Subject: EPA Comments on MidAmerican Energy Co, Walter Scott Junior Energy Center,  
Council Bluffs, IA  
Round 7 Draft Assessment Report

Re: Comments to Draft Coal Combustion Waste Impoundment Round 7 Dam Assessment Reports for Neal North Energy Center (Site #13), Walter Scott Energy Center (Site #14), Riverside Generating Station (Site #15 ), and Louisa Generating Station (Site #16)

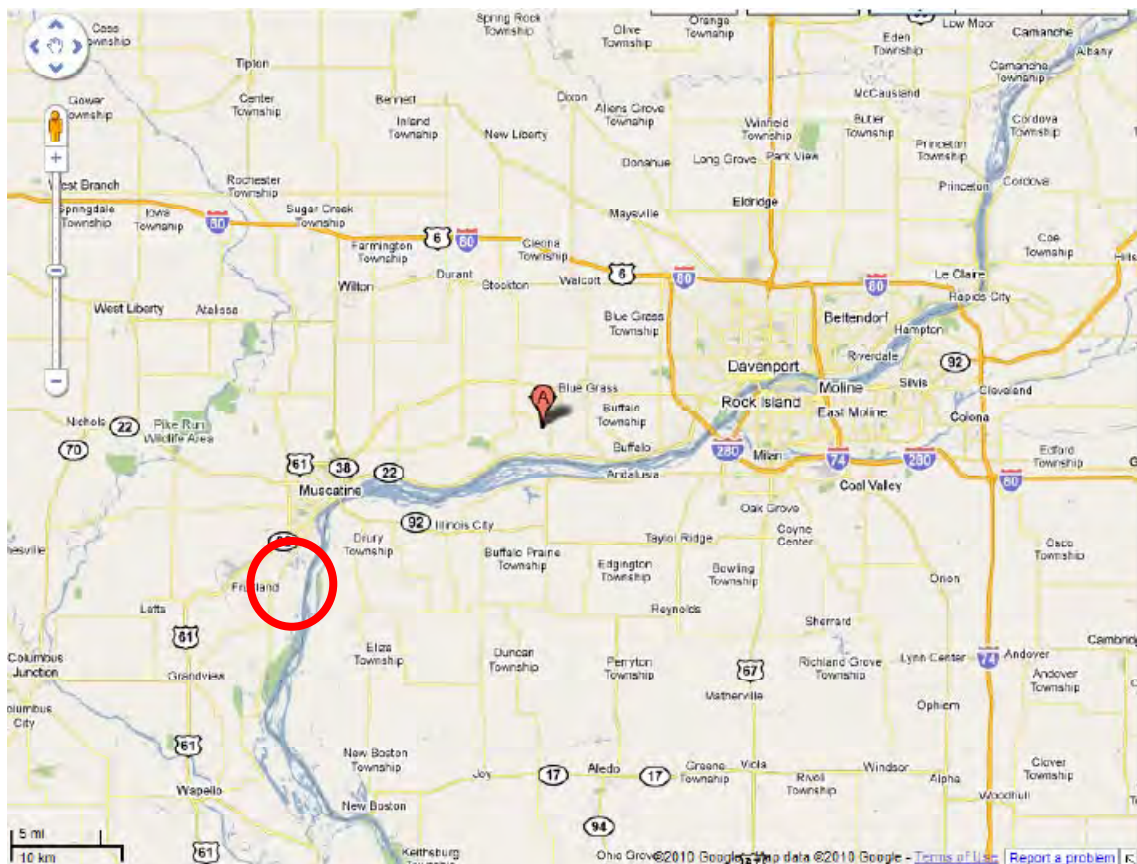
**Section 2.1:** The general description and figures 2.1a and 2.1b relate to IPSCO Steel, not Louisa. The Louisa Generating Station is further southwest near Fruitland, Iowa, as shown in the red circle on the map below.
